SERVICE BULLETIN 103 MANDATORY

SUBJECT: NOSE GEAR OVER-CENTER SPRINGS

APPLICATION: All Glasair III aircraft that are ready for taxi testing or are already flying

FIGURE (1)

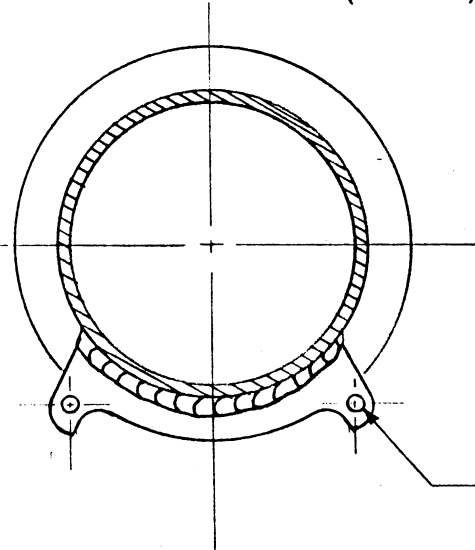
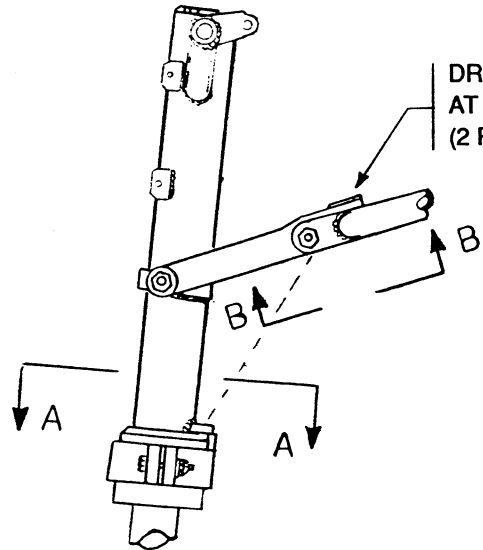
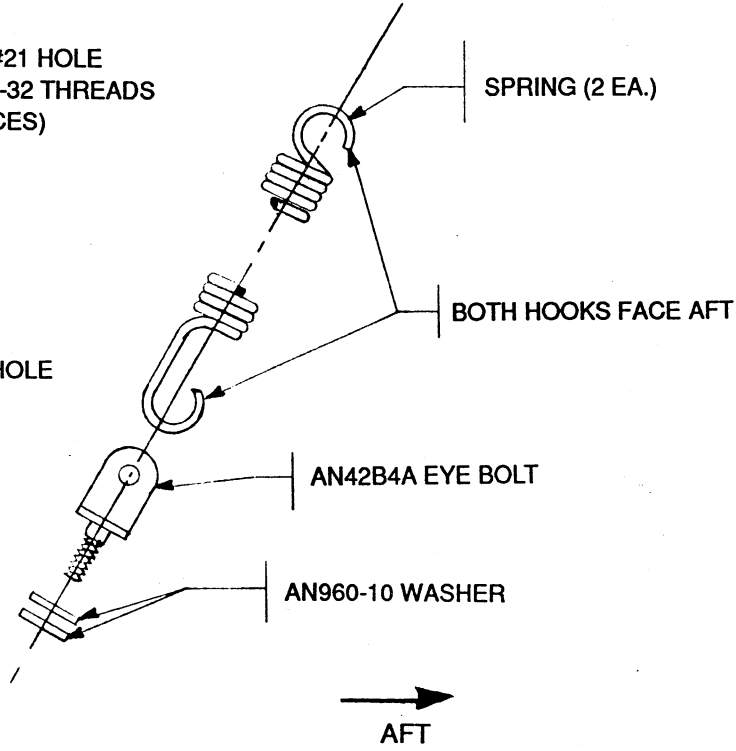
To assist the existing nose gear down lock spring, and to prevent the nose gear from collapsing if hydraulic pressure is lost, Stoddard-Hamilton Aircraft requires the installation of two nose gear over-center springs, as shown in FIGURE (1). The springs are to be installed between holes drilled in the curved plate at the forward end of the drag brace and eye bolts installed in the pivot stop plate on the nose gear strut.

Use a #21 drill bit to drill two holes in the nose gear pivot stop plate, which is part of the nose gear strut assembly, as shown in FIGURE (1). Drill parallel to the long axis of the oleo strut.

NOTE: Be careful when positioning the holes to provide clearance from the strut body for the 10-32 tap that will be used to cut the threads. If the tap contacts the strut body underneath the stop plate, it can break the tap.

Tap the holes with a 10-32 tap. Thread an AN42B4A eye bolt into each hole with two AN960-10 washers stacked under the shoulder of each bolt. Secure the eye bolts with Loc-tite thread lock adhesive.

Drill two 1/8" diameter holes in the curved plate at the forward end of the drag brace, as shown in FIGURE (1). Drill the holes at an angle to align with the axes of the installed springs.

Install the over-center springs, as shown, with the hooks at both ends oriented AFT. (The hook at the eye bolt end must face aft to allow the spring to clear the uplock actuating arm shaft when the gear is retracted; the hook at the drag brace end must face aft so that it does not tend to rotate out of the hole during gear operation.)

DRILL 1/8" DIA. HOLE
(2 PLACES)

DRILL #21 HOLE
TAP 10-32 THREADS
(2 PLACES)
